## REVISED RESPONSE TO REQUEST FOR ADDITIONAL INFORMATION

### APR1400 Design Certification

RAI No.: 396-8463

SRP Section: 12.3-12.4 – RADIATION PROTECTION DESIGN FEATURES

Fig.1 Fuel assembly position in the hoist box at the Up stop (RM)

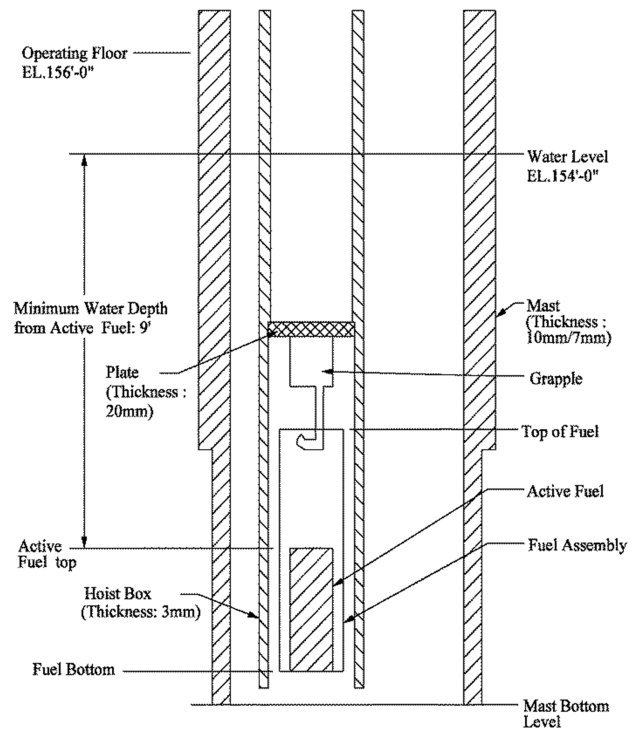
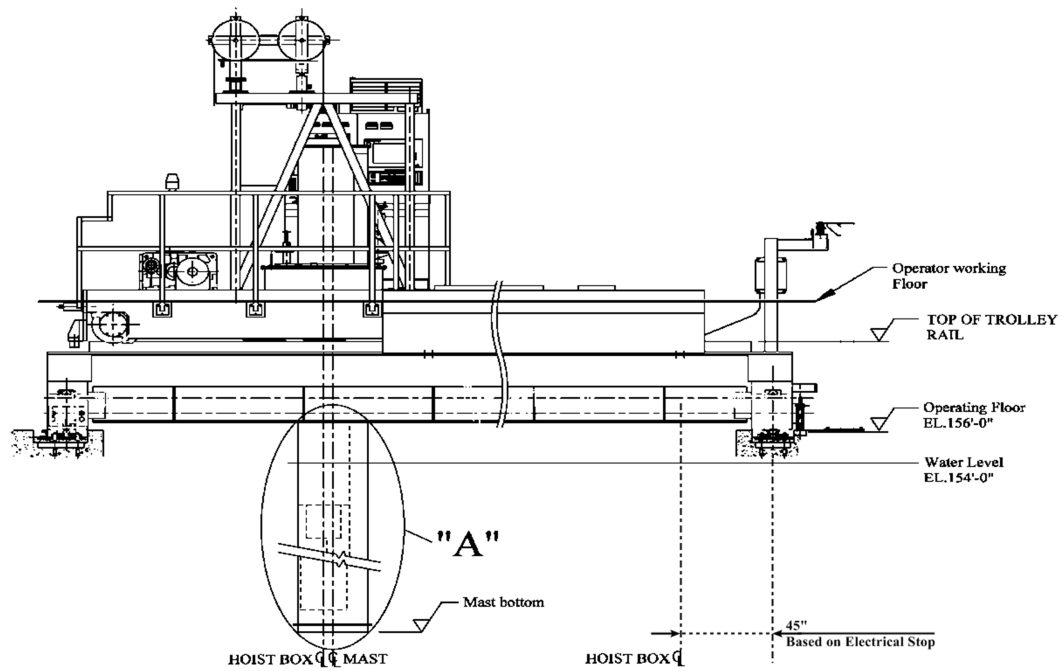
1. Please provide information on this shielding (such as what material the shielding is made out of, its density, its thickness, where it will be located, how it will be held in place, is the

refueling platform capable of holding the shield, and information demonstrating that it is adequate to ensure that the 2.5 mrem/hour criteria will be met).

#### I. Refueling Machine in refueling pool (Refer to Figure.1)

- a. Material specification
  - Grapple : 17-4 PH stainless steel
  - Mast/Hoist box : 304 SST
- b. SST Density : 0.29 lb/in<sup>3</sup> (8.03 g/cm<sup>3</sup>)
- c. Thickness
  - Mast : Upper part : 10 mm  
Lower part : 7 mm
  - Hoist box : 3 mm

Another working area for the operators during the fuel transfer operation is the operating floor (EL. 156'). The minimum distances from the centerline of the fuel assembly to the operating floor in the RP and SFP are 3'-9" (114.3 cm, Figure 1) and 4'-10.4" (148.34 cm, Figure 2), respectively. The dose rates on the operating floor of the RP and SFP are provided in Figures 6 and 7, respectively.

Fig. 3 DORT R-Z calculation model for Refueling Pool

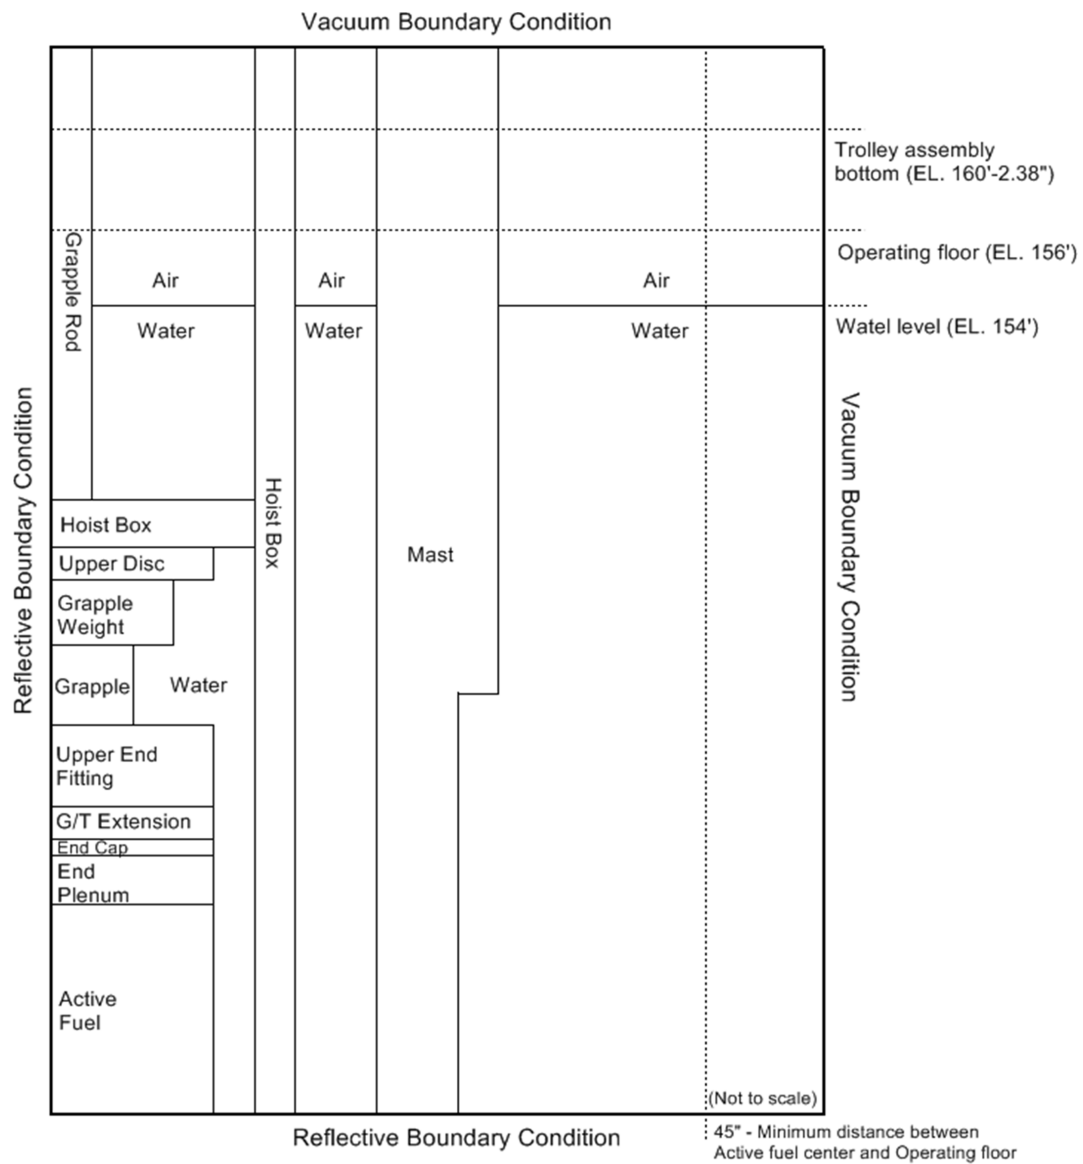
2. Update the FSAR to include information on the material, density, thickness, and location of the shields.
3. Since additional shielding is needed to reduce the dose to operators on the refueling platform and spent fuel pool handling machine platform to less than 2.5 mrem/hour, please provide additional information on the dose rate to personnel in the general refueling pool and spent fuel pool area during fuel movement. Indicate if any shielding or design features will be in place to ensure that the dose rate to these individuals will be in accordance with the 2.5 mrem/hour radiation zone designation provided for the general spent fuel pool area in FSAR Figure 12.3-7.

The shielding analysis models of the refueling pool (RP) and the spent fuel pool (SFP) for the DORT code are provided in Figures 3 and 4. The spent fuel assembly is modeled from the center of the active fuel to the upper end fitting. And the fuel handling tools (grapple, grapple weight and grapple rod) and the hoist box are included in the model. Water is modeled to cover up to 9' above the active fuel and dry-air is modeled above the water. For the refueling pool model, the mast of the refueling machine is included. Other structures in the RP and SFP are not considered in these analyses for the purpose of conservatism.
